DOCUMENT NO: OP-1903.034

TITLE: EMERGENCY OPERATIONS FACILITY
EVACUATION

REVISION NO: 014-00-0

CHANGE NO: AP-14

ALTERNATE EOF WORK AREAS AND ROOM ASSIGNMENTS

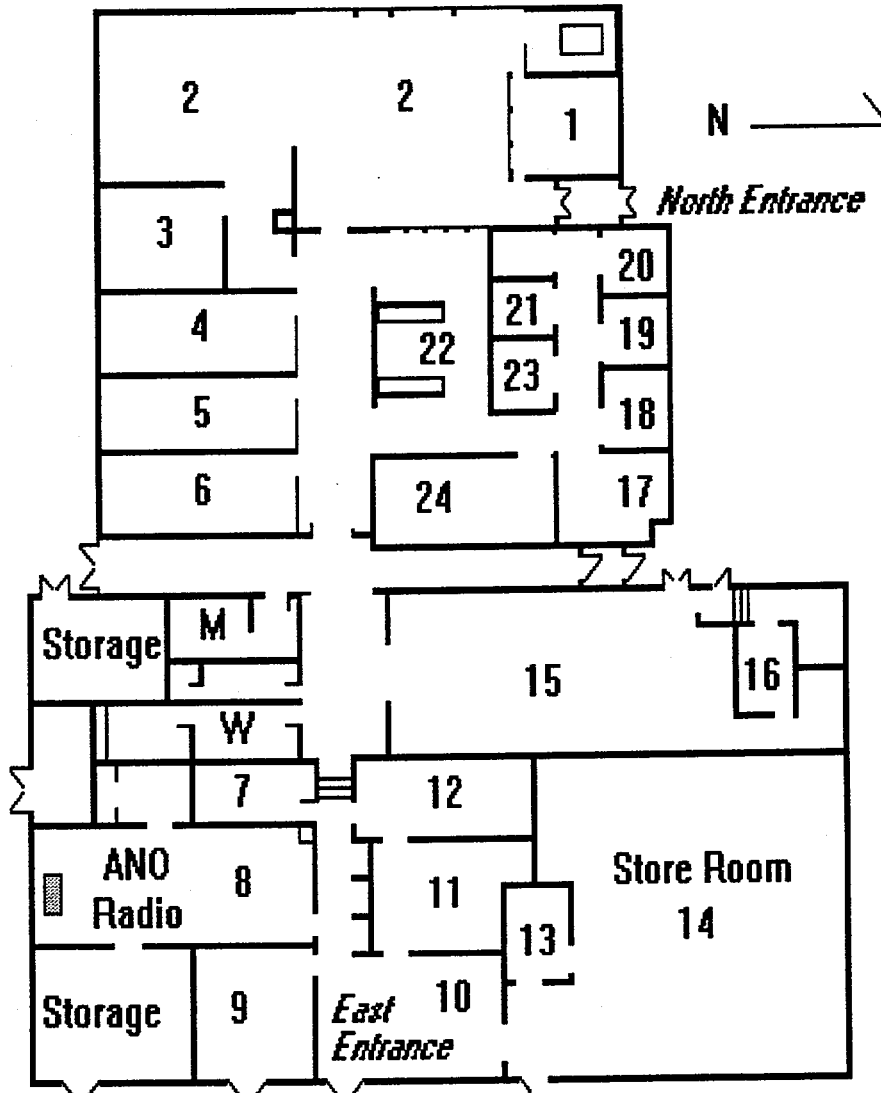
AFFECTED SECTION: (Include step # if applicable)	DESCRIPTION OF CHANGE: (For each change made, include sufficient detail to describe reason for the change.)
Table of Contents	Added 7.1.7 (Attachment 7)
3.4	Added Bold and Brackets, Added commitment.
6.1.2	Added statements for Precautionary, Attachment 7 and criteria.
6.2	Added statements for Attachment 7.
6.3.1.D	Added statements for Attachment 7.
6.3.2	Added statements for Attachment 7.
6.3.2.B	Added statements for Attachment 7.
7.1.7	Added Attachment 7.
Attachment 2, Step 3,5	Added statement for Attachment 7.
Attachment 3, Step A.2.b	Added statement for Atkins Center
Attachment 3, Step A.3.a	Changed statement for clarification.
Attachment 4, 5	Removed REAM Assistant
Attachment 7	New Attachment
